Farmington City Planning Commission
Special Meeting

Planning Commission Staff Report March 10, 2016

Item 3: Preliminary Plat for the Residences at Farmington Hills Subdivision

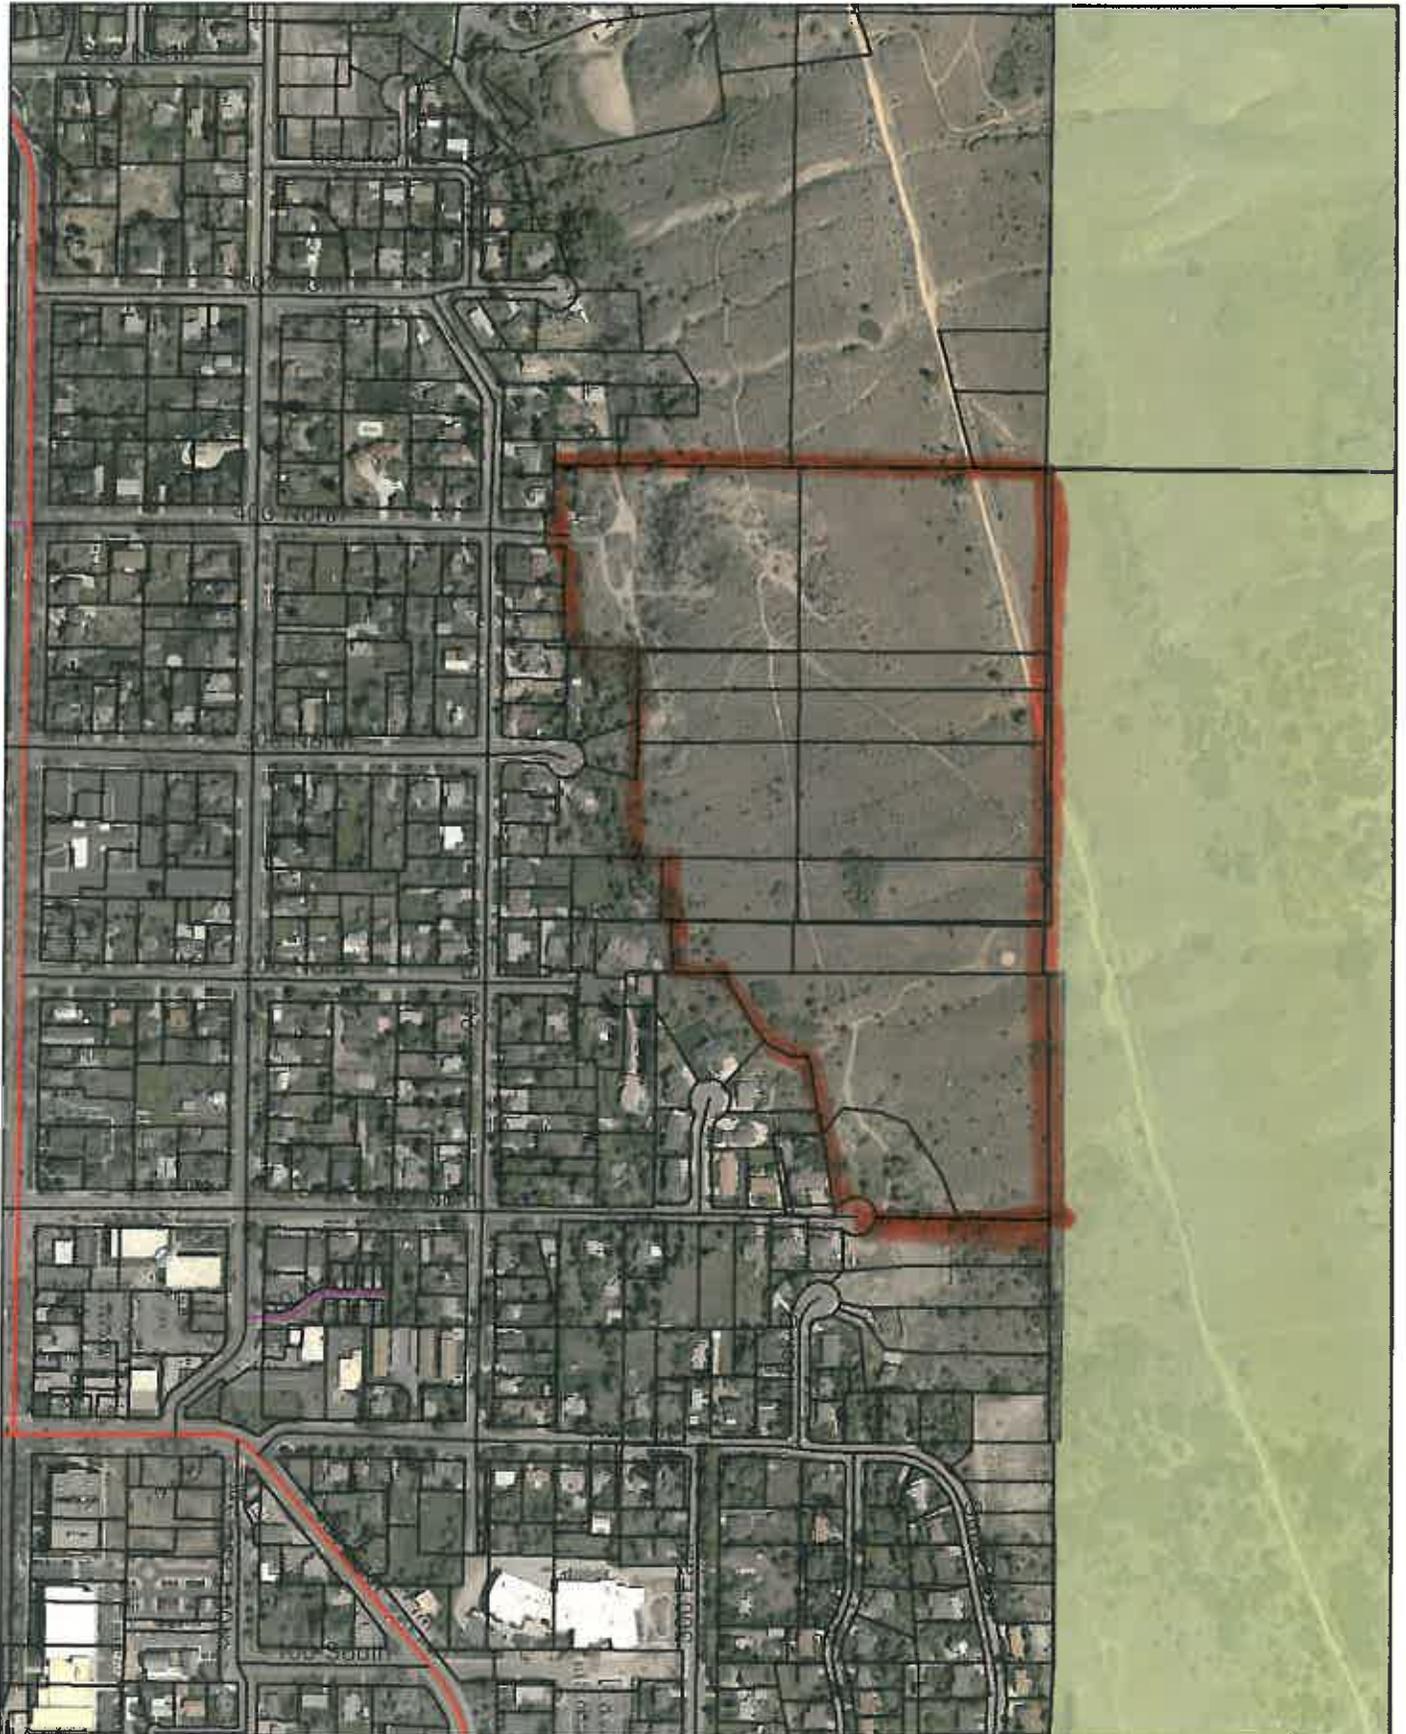
The preliminary plat provided to us does not incorporate recommendations provided in the geologic and geotechnical studies. The subdivision layout should be modified to include recommendations from these studies along with additional information developed by the geologic/geotechnical consultant with completion of additional studies recommended herein.

**Plate
A-3**

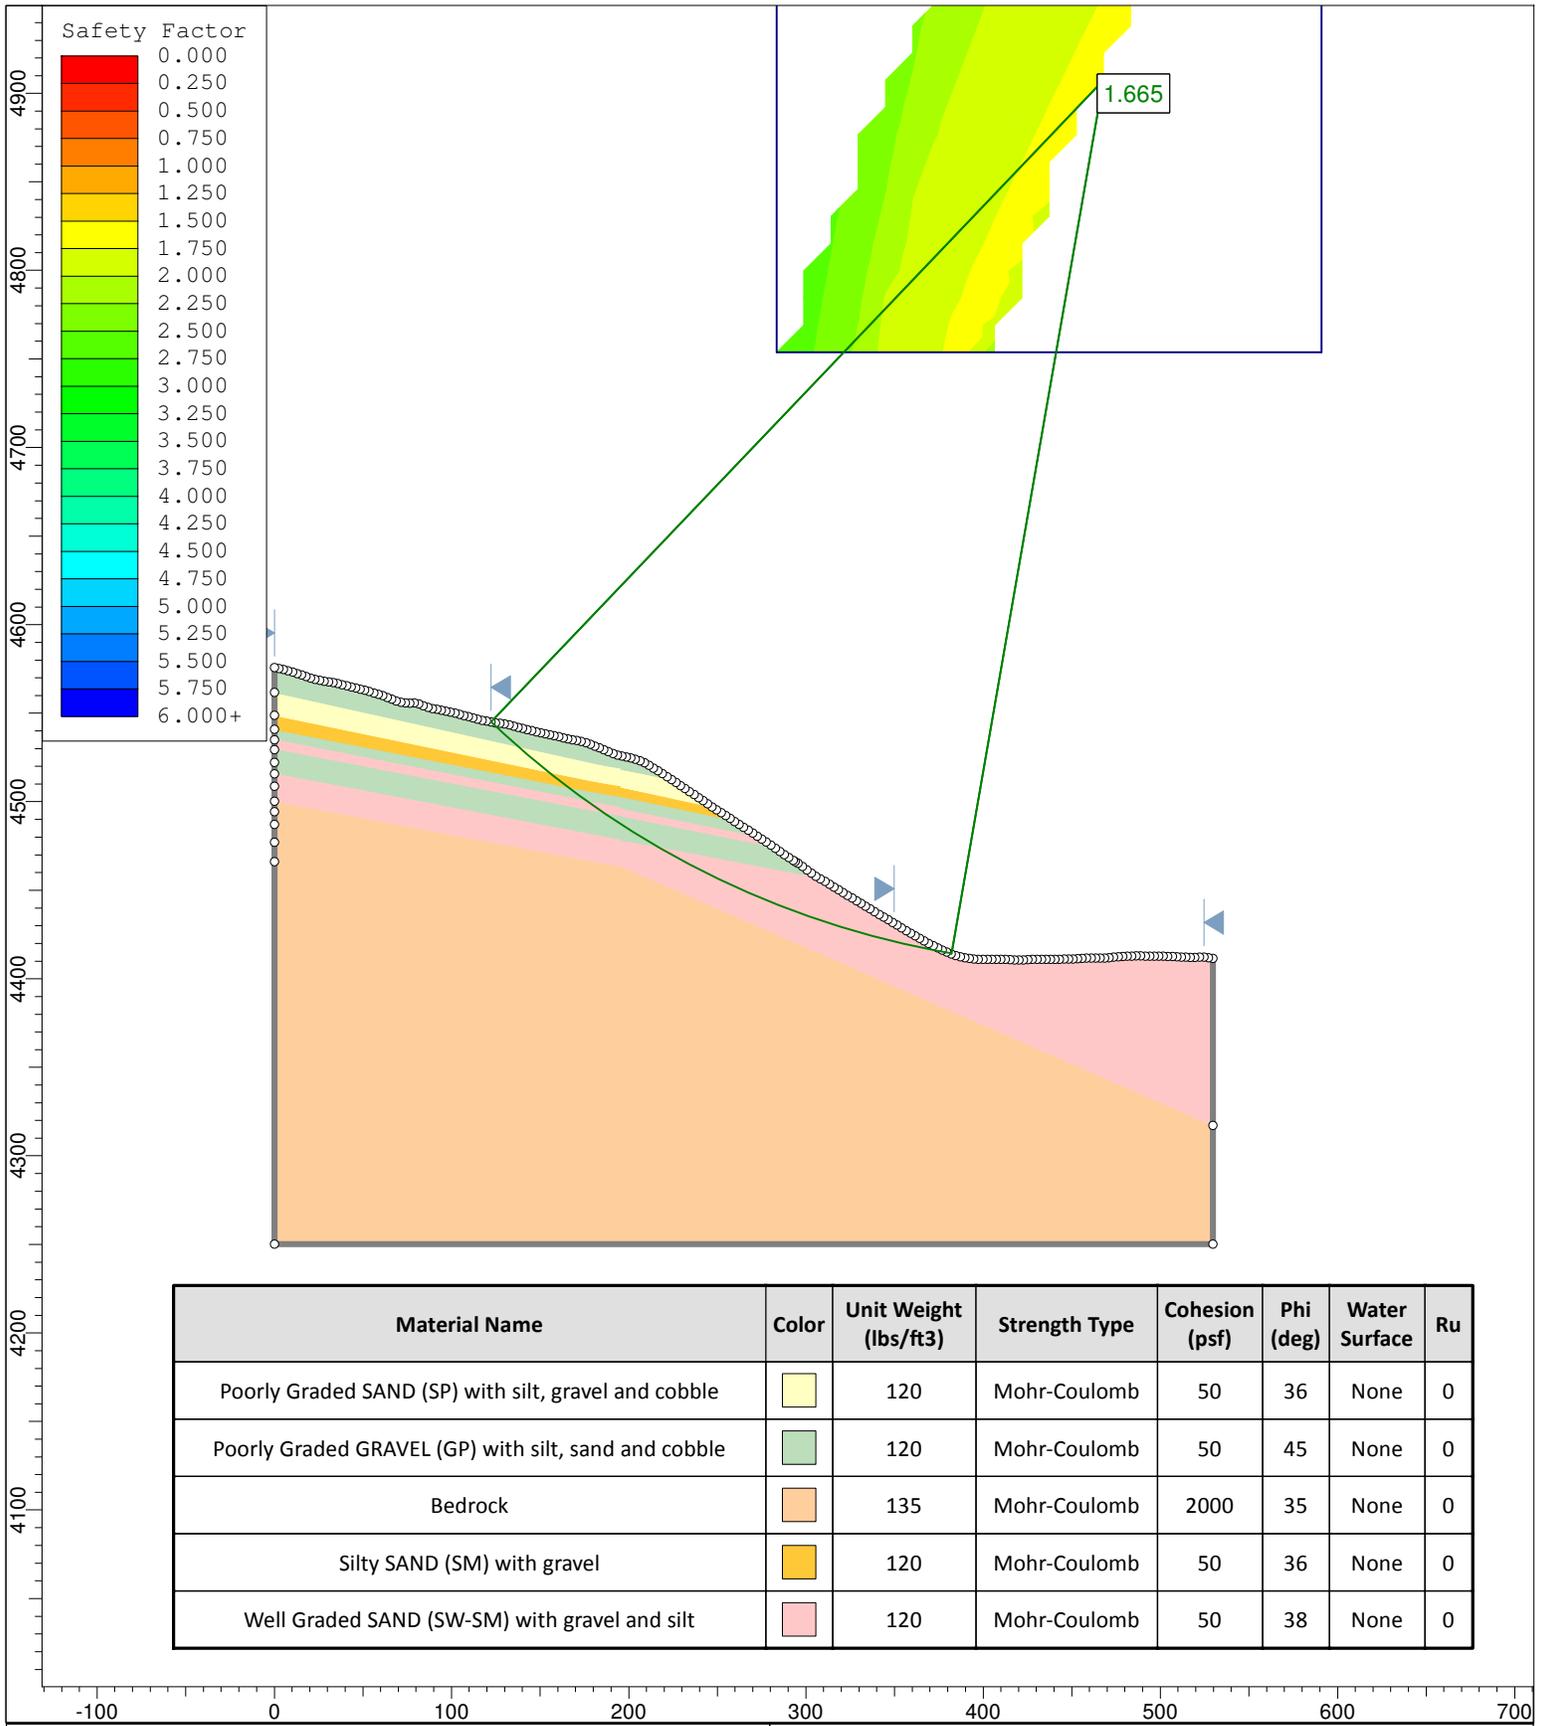
11. The building envelopes on Lots 1-5 are dependent on the results of final trenching, and Lot 13 is not buildable, and the envelopes on all lots must be consistent with Plate A-3 of the Revised

Geotechnical Study, unless presented otherwise by the geotech with a recommendation from the City's consultants.
